## Submission – Proposed Planning Scheme Amendment C244melt

SPOT Planning continues to act on behalf of Yale Asset Development 2 with respect to their interest in the following parcels within the future Melton East Precinct Structure Plan (PSP) area:

PROPOSED DRAINAGE SCHEME PLAN FOR MELTON EAST PSP

Indicative Drainage Scheme Design

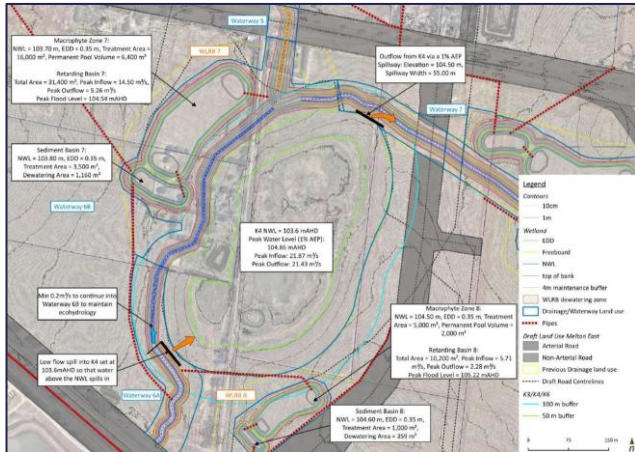
DPM Consulting have undertaken a Preliminary Drainage Investigation and have prepared an Indicative Drainage Scheme Design (limit of DSS investigations to subject site without investigating downstream) to provide a more efficient outcome, without the protection of these environmental values or applied predicted archaeological sensitivity buffers. The Indicative Drainage Scheme Design adopts a more distributed approach in comparison to the existing Scheme Design, with more drainage assets within the precinct but at a much smaller scale. The alternative Drainage Scheme design would not only reduce the cost to the Drainage Scheme charges but would increase the developable area of the precinct by conservatively 10ha.

The Indicative Drainage Scheme Design as prepared by DPM Consulting has been overlaid on the PSP to demonstrate the alternative outcome. The Indicative Drainage Scheme Design is provided as **Appendix B** for reference.

*In summary, it is recommended to refine the Drainage Scheme Design to exclude the protection of Seasonal Herbaceous Wetlands and the predicted archaeological sensitivity buffer in order to provide for the most efficient drainage design for the precinct.*

K4 – Functional Design

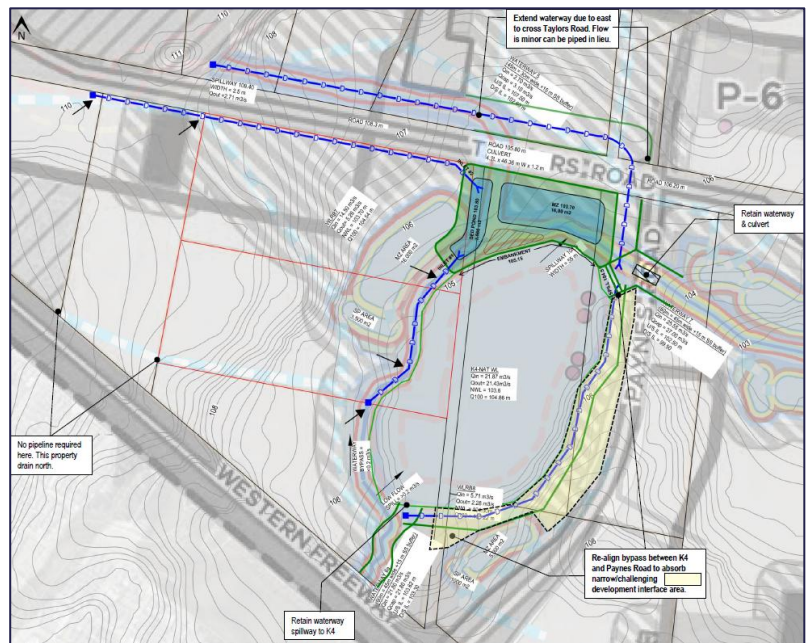
As such, should the Panel recommend the protection/preservation of these wetlands within the precinct – despite the MSA Program intentions and the separate requirements of the *Aboriginal Heritage Act 2006* and the associated Regulations, it is recommended to re-design the drainage infrastructure surrounding by Kororoit Wetland K4 to maximise the functionality of developable area as follows:

- Re-align the bypass to the east of K4 to absorb the undesirable 'developable area' wedged between the drainage infrastructure and Paynes Road.
- Re-locate the Sediment Pond and Macrophyte Zone to the north of K4 to absorb the undesirable 'developable area' wedged between drainage infrastructure and Taylors Road.
- Extend the waterway north of Taylors Road, further to the east to cross Taylors Road at the appropriate locations as a result of the modified drainage design or pipe these flows to mitigate impact.

*In summary, should the Panel determine that the Seasonal Herbaceous Wetlands should be protected/retained, along with the predicted archaeological sensitivity buffer as part of the Melton East Precinct Structure Plan, the drainage infrastructure surrounding Kororoit Wetland K4 is recommended to be updated as per the Concept Design prepared by DPM in order to reduce the undesirable 'developable area' between the drainage assets and the adjoining Arterial Roads and maximise the functional and usable developable area.*

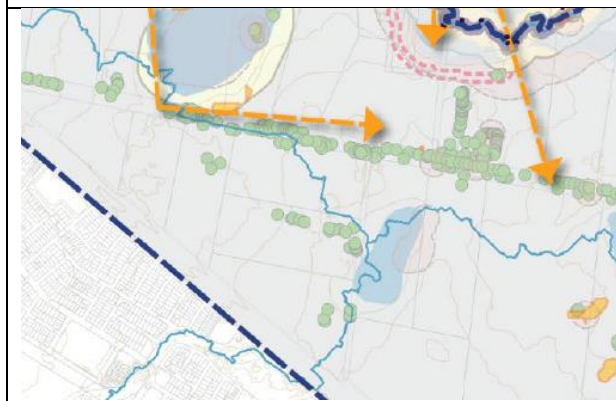
We note the defendable space requirements of Plan 9 – Bushfire and the 19m Bushfire Hazard A setback applying to the interface to the drainage infrastructure at the subject site.

Nevertheless, it is requested that the cross section include a notation to more clearly demonstrate that the defendable space is required between the encumbered open space/drainage reserve boundary and the dwelling built form.

As such, allowing for the front setbacks and yards of dwellings to provide for this defendable space setback as long as controls are in place to ensure the entire defendable space is provided between the building line and the open space/drainage reserve boundary.

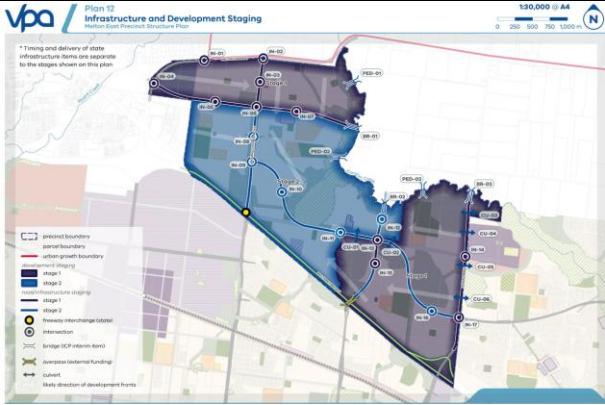
**R62** Staging of infrastructure and development must be generally in accordance with Plan 12 Infrastructure and Development Staging and Appendix 1 Plan 13 Precinct Infrastructure Plan, and must provide for the timely provision and delivery of infrastructure to the satisfaction of the responsible authority

We note our submission above to delete Plan 12 Infrastructure and Development Staging due to the lack of empirical justification. As such, it is recommended to delete requirement 62.

**Figure 2 - Current functional design for WLRB7 and Waterway 6B (Alluvium, 2025)**

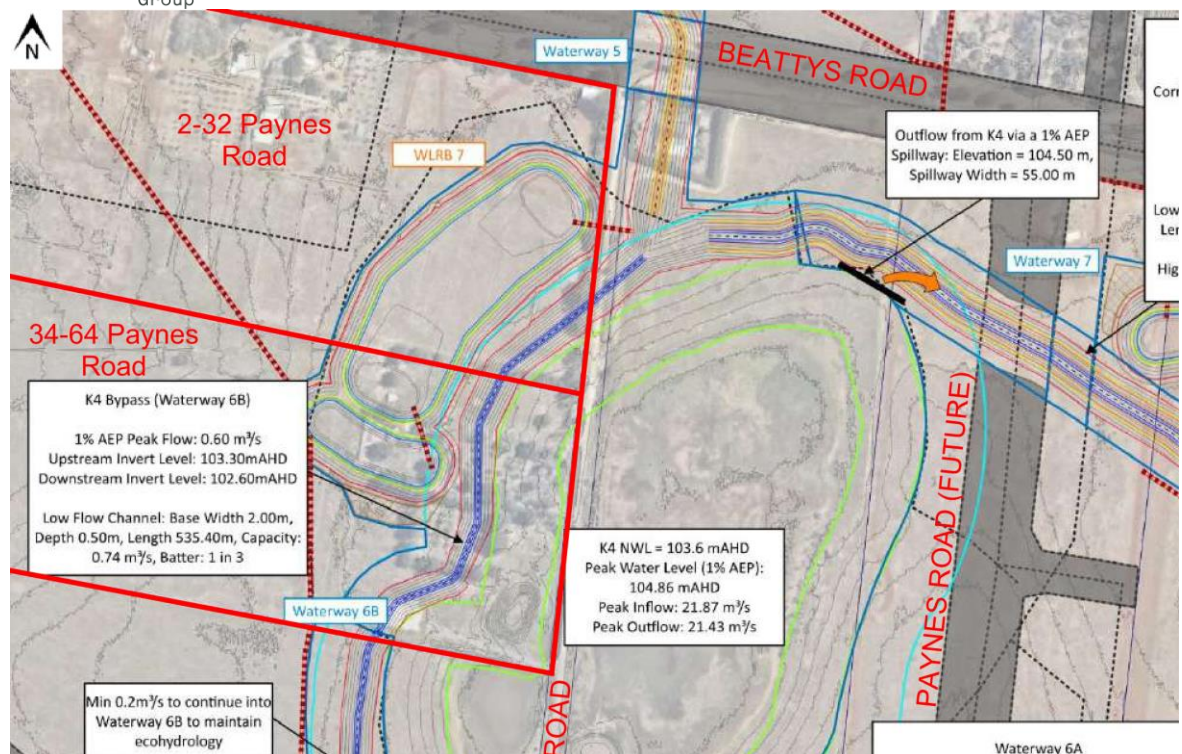
Based on our review of the current functional design proposed by Alluvium we generally agree with design parameters adopted. However, we have proposed an alternate location for “WLRB 7” as we believe that there is a significant opportunity to utilise constrained land in the PSP and recover land more suitable for Net Developable Area (NDA).

Figure 3 - Proposed DPM Concept Design for “WLRB 7”

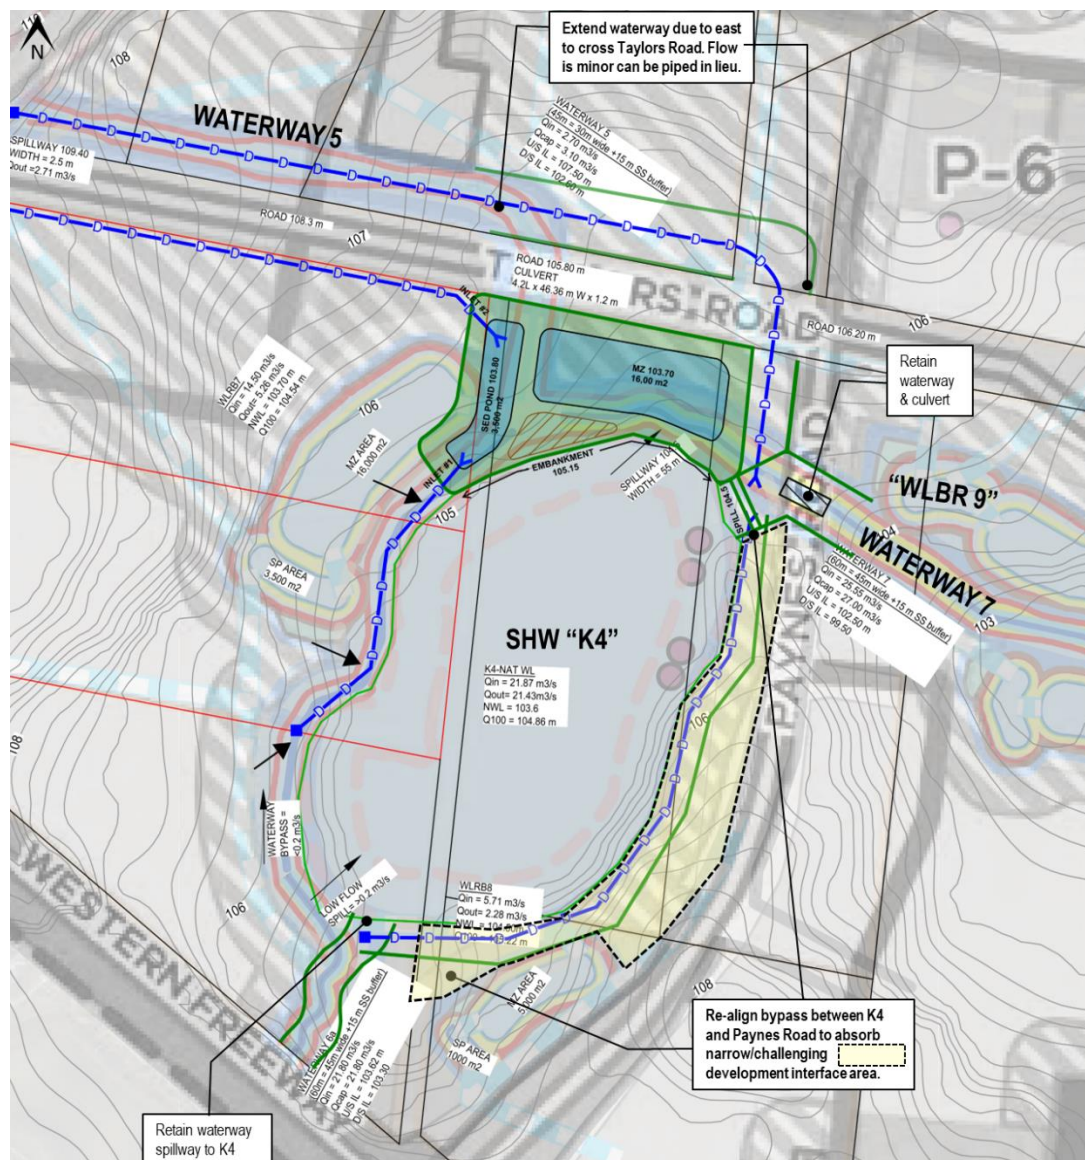
The efficiency of the DPM design lies in enabling the wetland to be relocated to a narrower and more constrained parcel of land within the PSP. It is submitted that wetland “WLRB 7” is relocated further north-east and bounded by Taylors Road, Paynes Road and the “K4” SHW. This avoids encroachment into land better suited for urban development. It also relocates “WLRB 7” in a lower laying area which previously relied on being serviced by the next-most downstream wetland referred to as “WLRB 9”. It also extends the wetland’s contributing catchment boundary to a more definitive and logical location at the Paynes Road waterway crossing.

Figure 4: Cross-section taken halfway along “Waterway 6B”

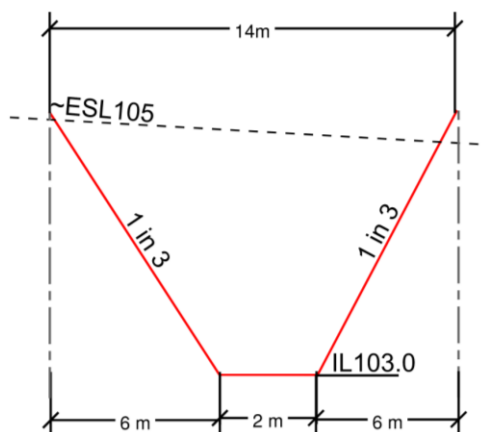
The current Alluvium design proposes a bypass waterway with a capacity of  $0.74 \text{ m}^3/\text{s}$  with a design flow of  $\geq 0.2 \text{ m}^3/\text{s}$  to replicate the wetting regime of SHW “K4”. A cross-section taken approximately half-way through the waterway alignment based on the existing surface and the proposed invert levels in Alluvium’s functional design is provided in Figure 4 below.

The waterway commands a top width in the order of 14 metres.

**Figure 5 - Waterway 5 (Alluvium, 2025)**

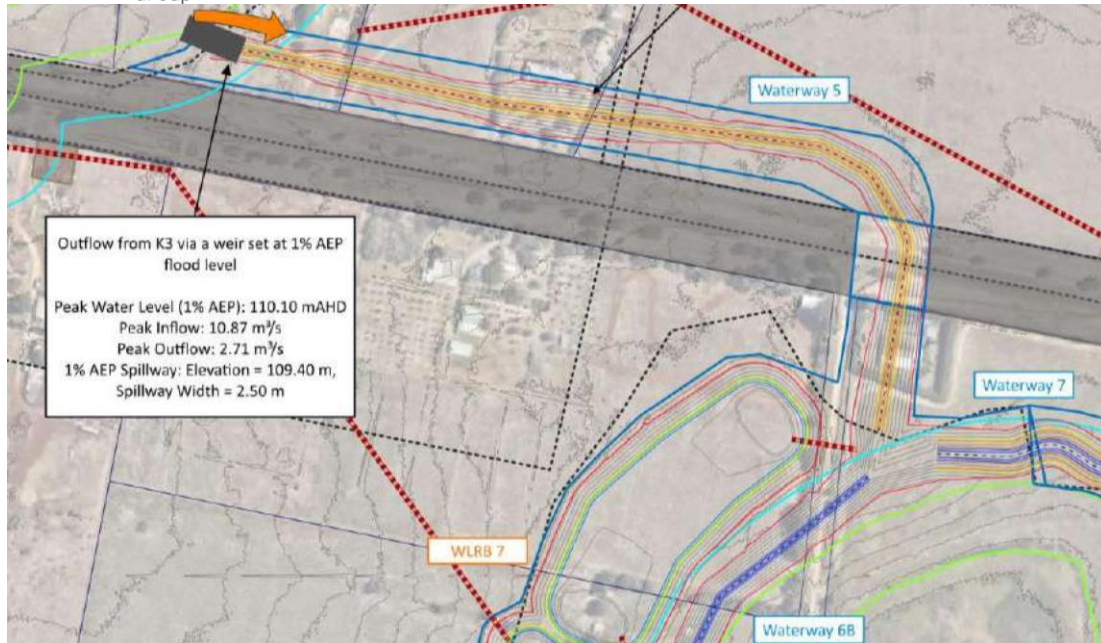
Waterway 5 conveys the outflow from SHW “K3” which is in the order of  $2.7 \text{ m}^3/\text{s}$  as shown in Figure 5.

A flow of this magnitude can be contained in a 1200 mm diameter drain running at an average grade of 1 in 150, which is achievable based on the natural topography and the proposed upstream and downstream invert of this waterway.
